**CITY OF BATON ROUGE
PARISH OF EAST BATON ROUGE
DEPARTMENT OF ENVIRONMENTAL SERVICES**

ADDENDUM NO. 2

SUBJECT: **HOOPER ROAD PUMP STATION PROJECT
CITY-PARISH PROJECT NO. 10-PS-GS-0048**

PUMP STATION NO. : 86
STATION LOSSES: INCLUDED
DESIGN CONDITIONS: 555 GPM @ 81 FT TDH

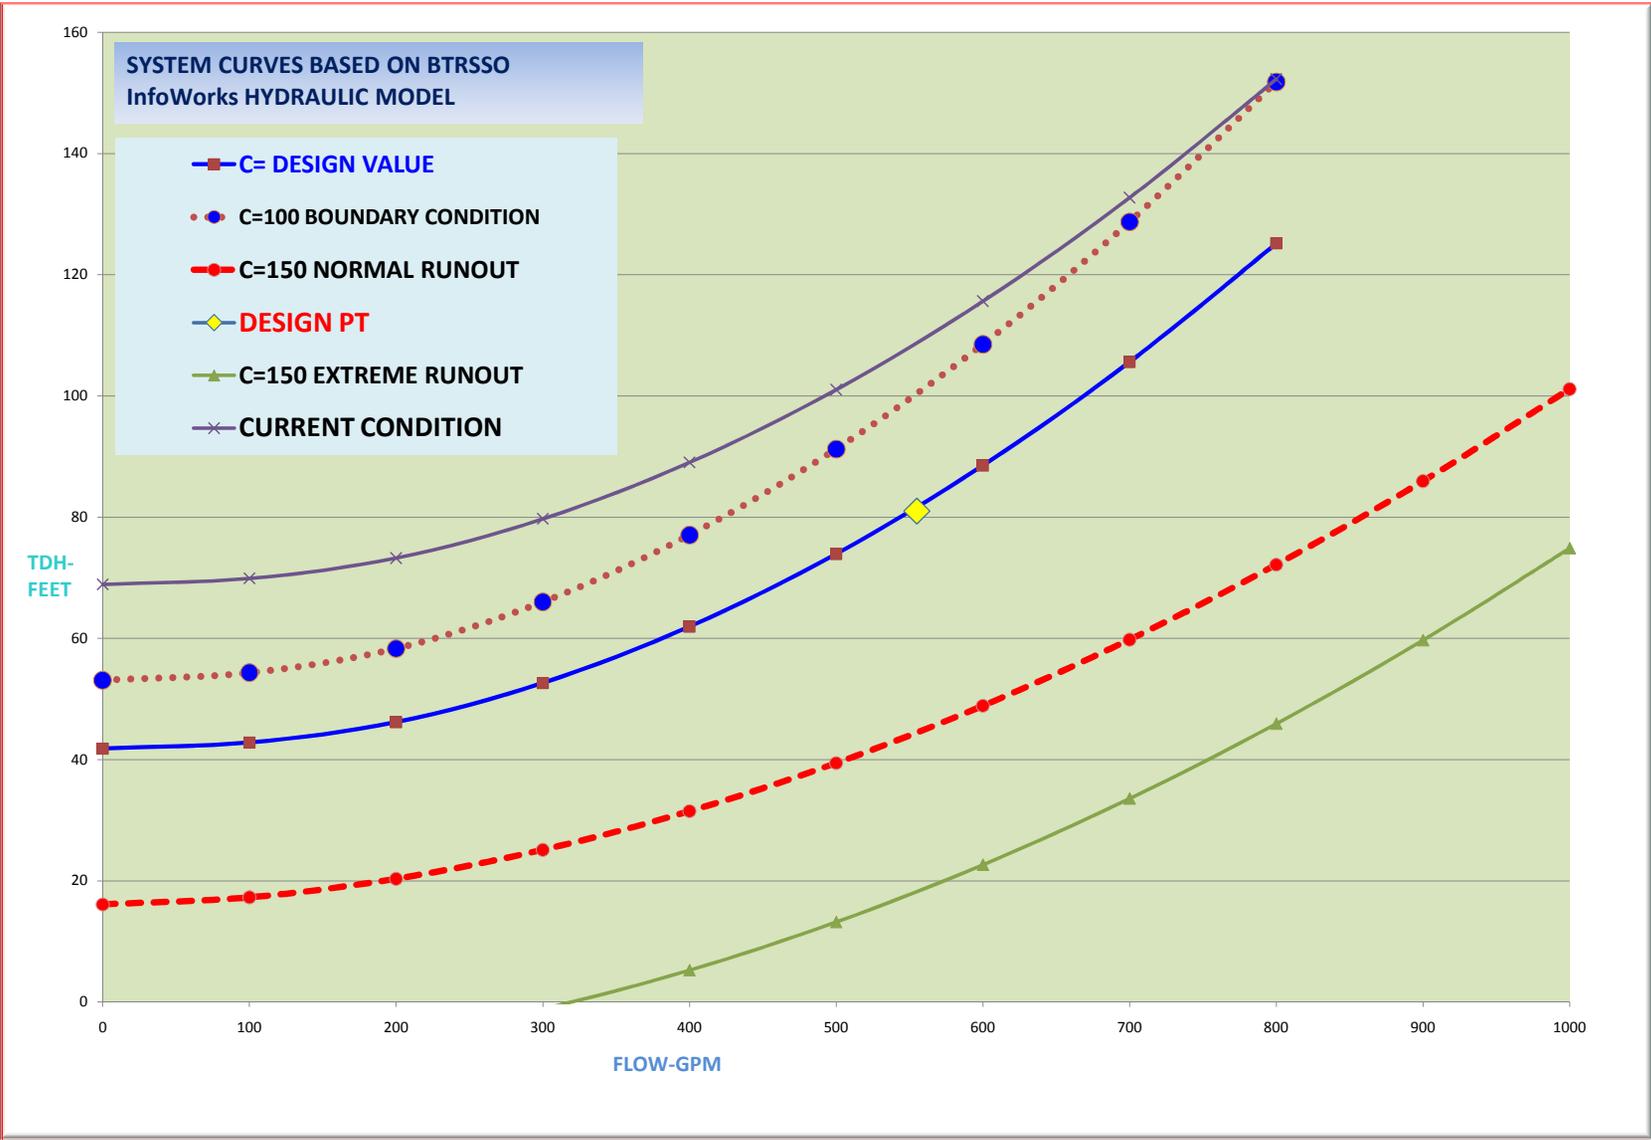
2. Please provide the system curves for these stations.

System Curves have been provided as Exhibit 1 in this addendum.

EXHIBIT 2: PUMP STATION 511
JACK AND BORE RECORD DRAWINGS

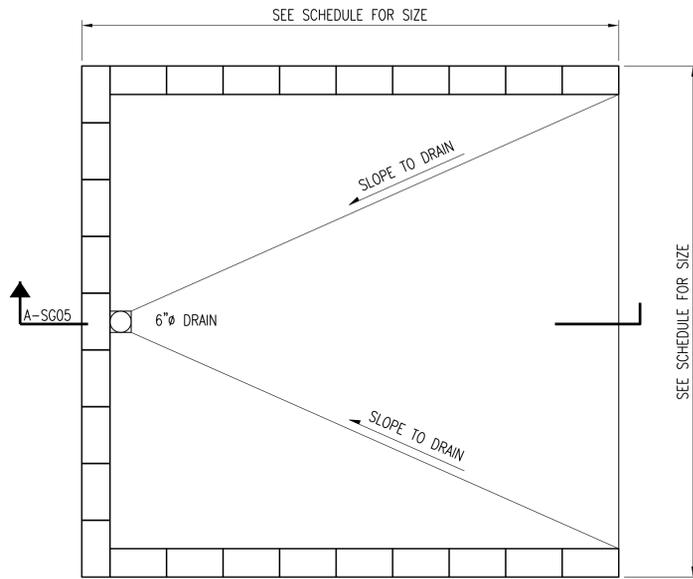
8. At PS511 the existing casing pipe shall be reused for the new 36" carrier pipe. The existing carrier pipe is 30".

- a. What is the size of the existing casing pipe?

- b. Will the existing casing pipe be of sufficient size for the increased pipe size?

- c. Is the existing 30" carrier pipe grouted into the casing pipe? If yes, how should we demolish this pipe?

The existing casing is 48" in diameter.

Yes.

To the best of our records, the carrier pipe is not grouted in. Contractor to verify condition of casing prior to beginning work at this site. See Record Drawings for existing casing included as Exhibit 2.

EQUIPMENT PAD AT GRADE DETAIL
NO SCALE

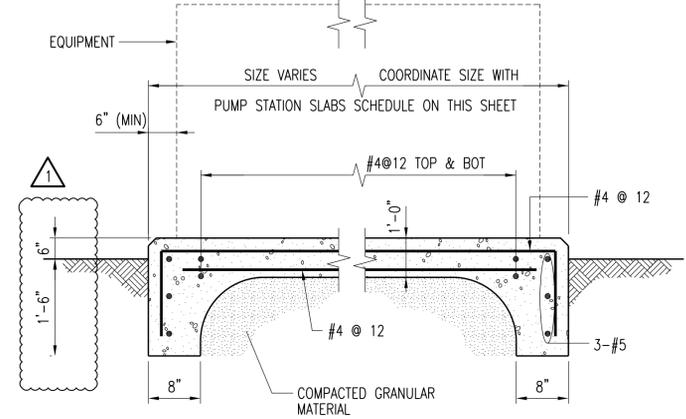
23. Drawing SG05, equipment pad at grade detail, shows a slab thickness of 1'-0" in the middle. The above grade dimension at the footings is 6". Please clarify the equipment pad thickness.

The equipment pad is 1'-0" thick and the top of the pad should be 6" above the existing or finish grade.

SHEET NUMBER		P-C02R	
EAST BATON ROUGE		BATON ROUGE	
PARISH		CITY	
DESIGNED BJR		PROJECT 10-PS-MS-0048	
CHECKED JRS		DATE 04-01-2016	
DETAILED		SHEET 051 OF 175	
CHECKED		REVISION DESCRIPTION	
DATE		NO.	
BY		DATE	
JRS		05/31/16	
SHOWED SCREENED D.I. VENT PIPE		1	
REVISION DESCRIPTION		DATE

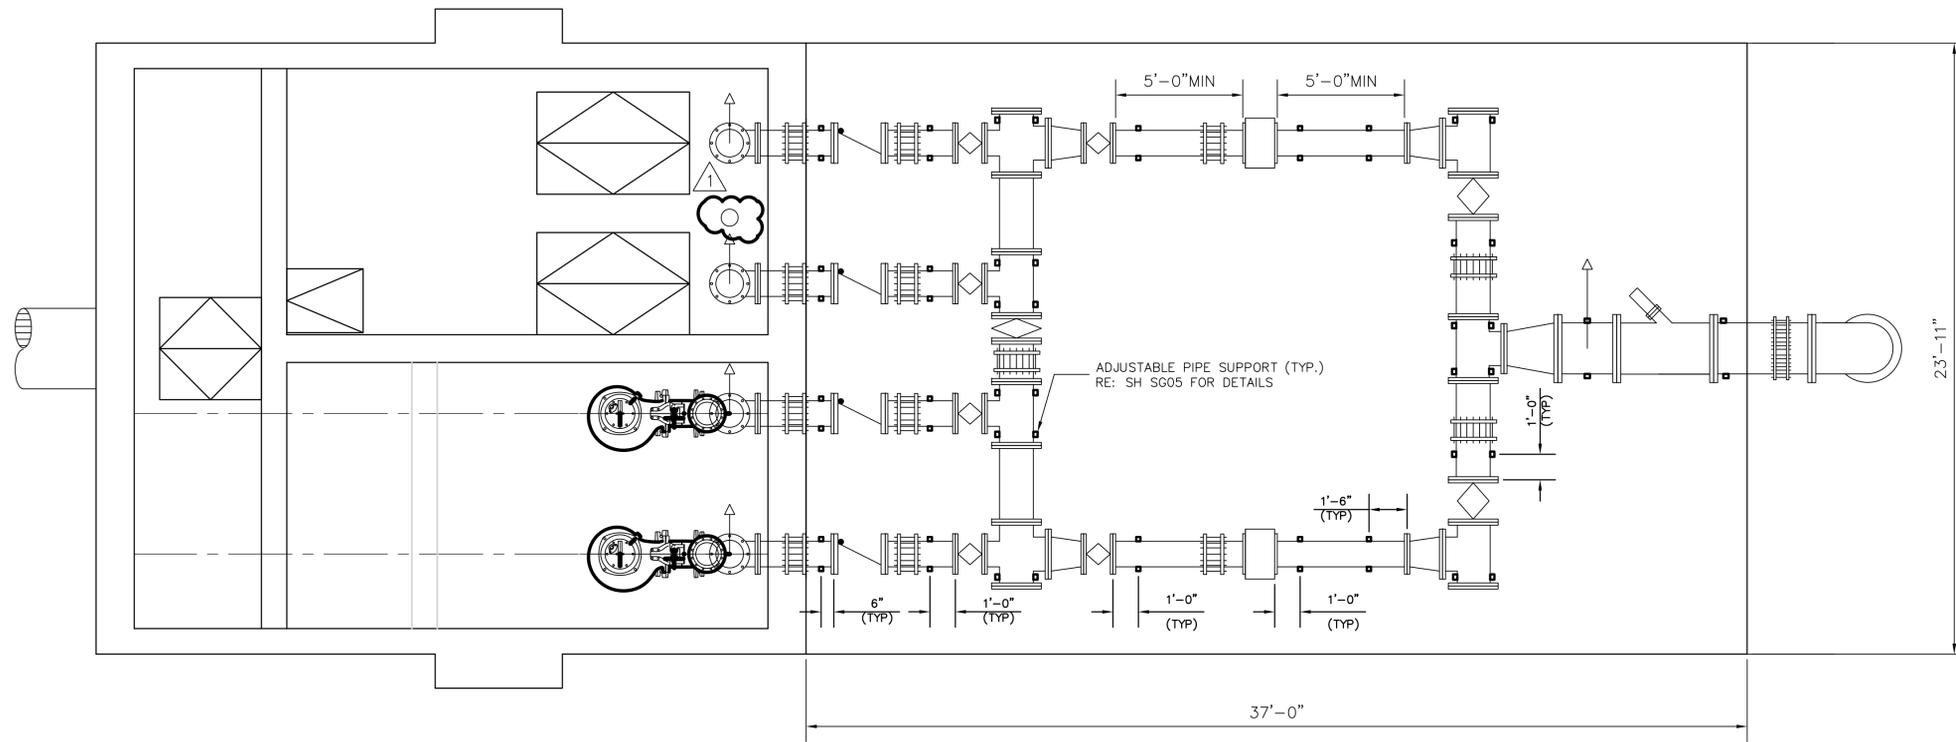
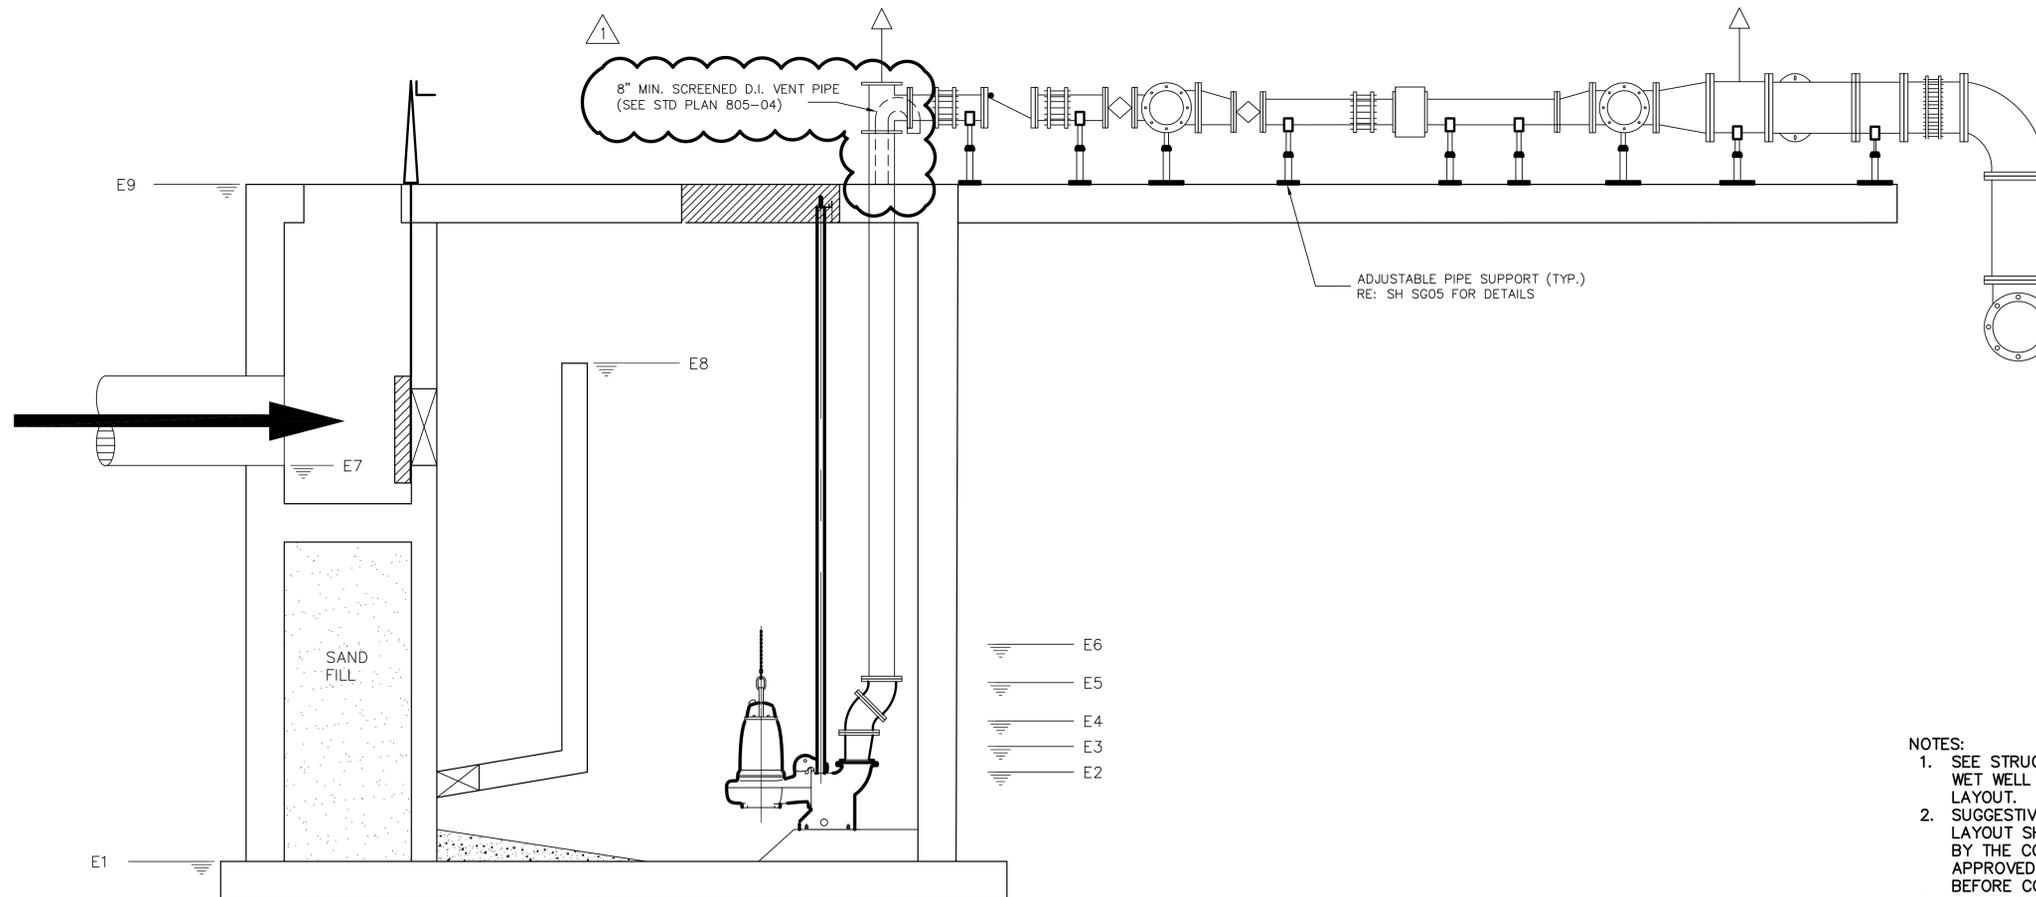
28. *On sheet P-C01 it shows a note stating that the concrete drive is 15' wide. However, it does not show/mention the thickness of the concrete. Based on the other pump station drawings I'm assuming that the drive will be 8" thick. Can you please confirm this.*

The drive shown on P-C01 is 8" thick.

SHEET NUMBER	Q-C02R
PARISH	EAST BATON ROUGE
CITY	BATON ROUGE
PROJECT	10-PS-MS-0048
DESIGNED BY	JRS
CHECKED BY	JRS
DATE	04-01-2016
NO. OF SHEETS	175
NO.	4
DATE	05/31/16
REVISION DESCRIPTION	SHOWED SCREENED D.I. VENT PIPE AND ADDED NOTE 4

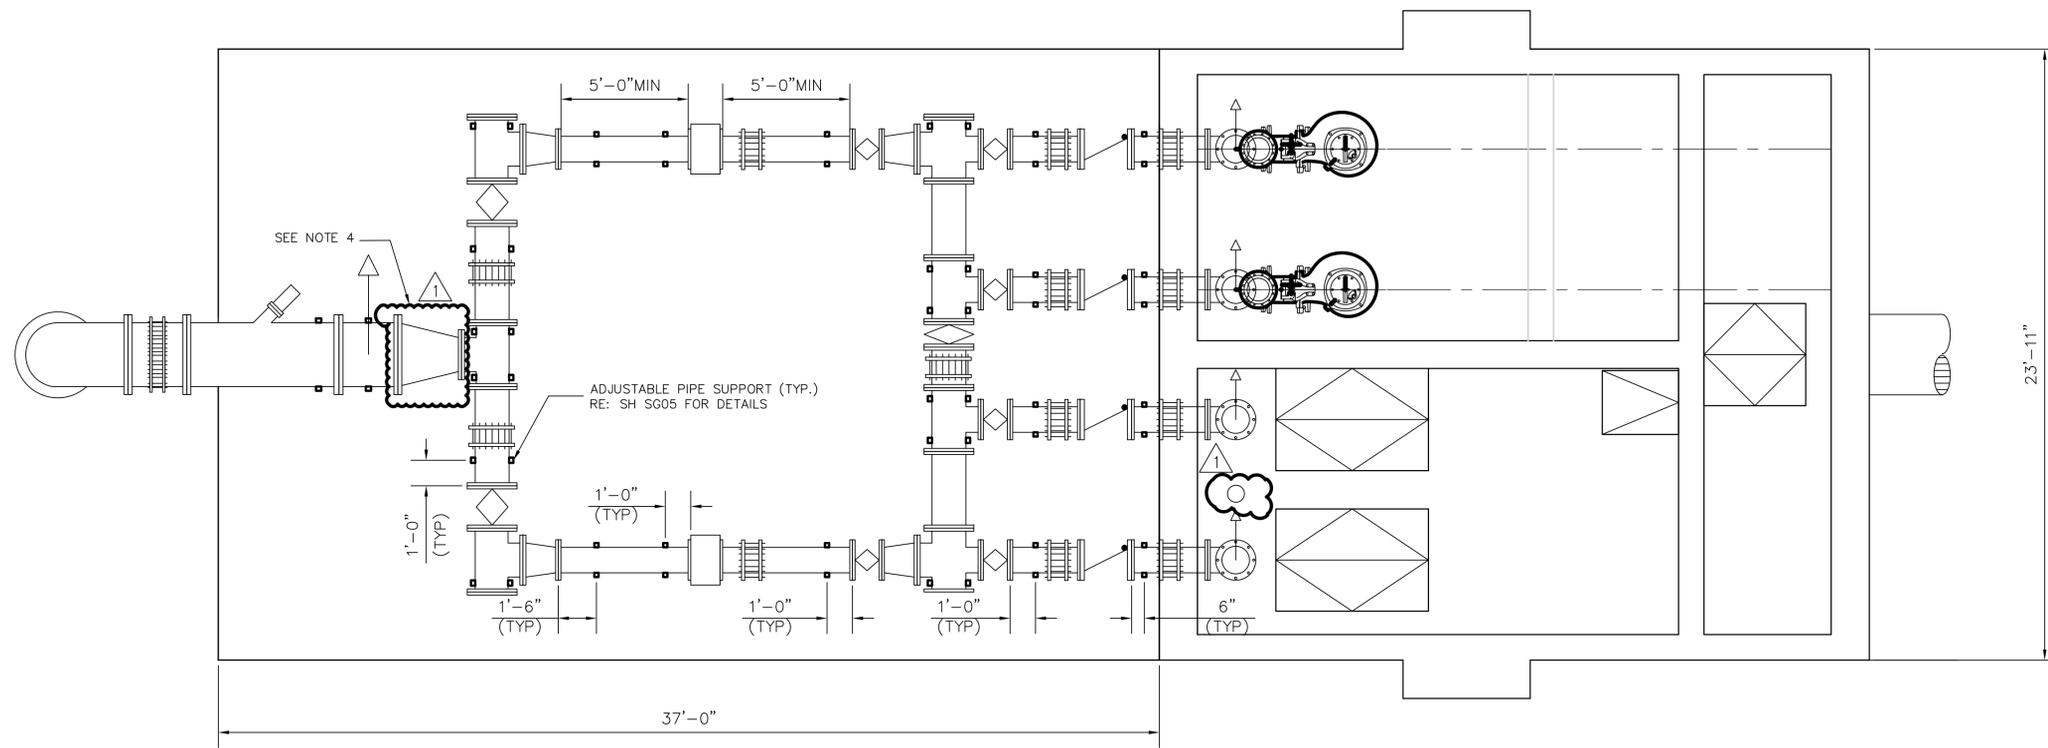
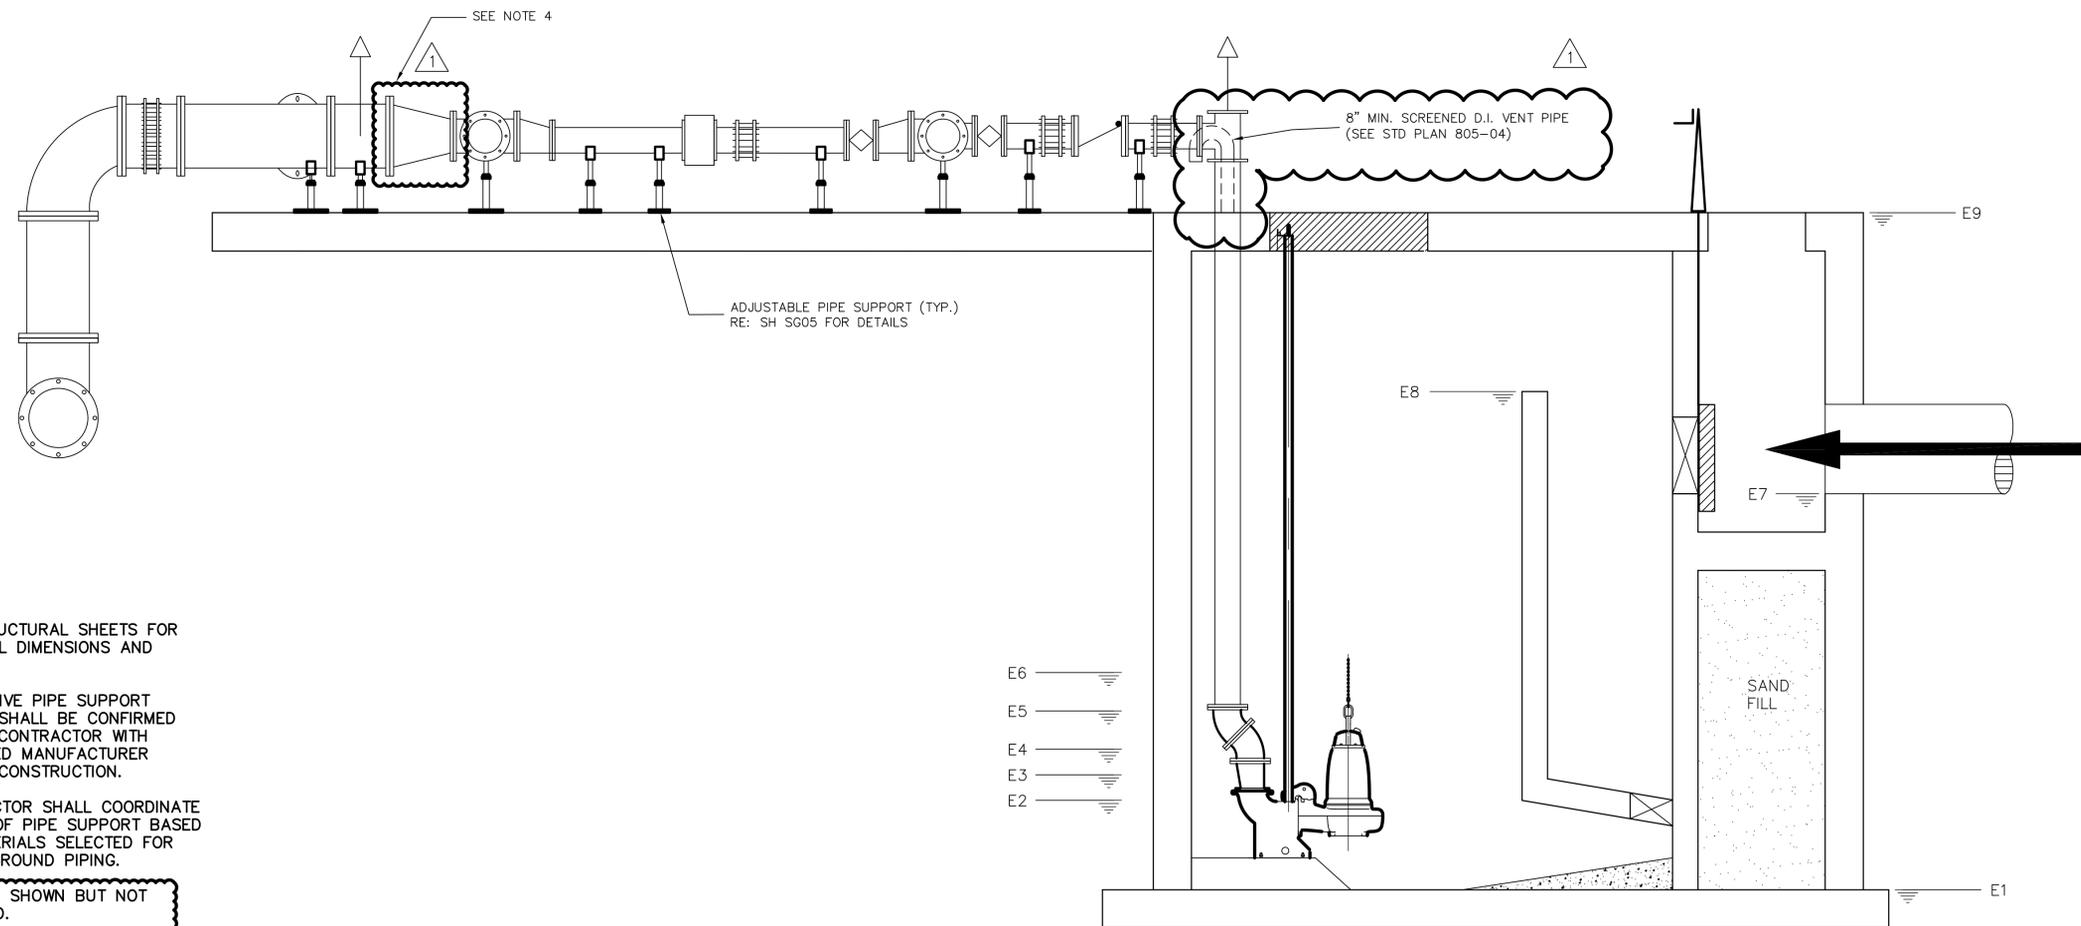
4. Sheet Q-C02 & 3; the pump discharge is 14", the ppg coming off the end of the pump appears to enlarge, the vertical riser does not show a pipe size; however, the ppg above the station appears to be 12". Where does the discharge change to 12" and what is the size of the riser ppg?

See revised sheets in this addendum.

4. REDUCER SHOWN BUT NOT REQUIRED.
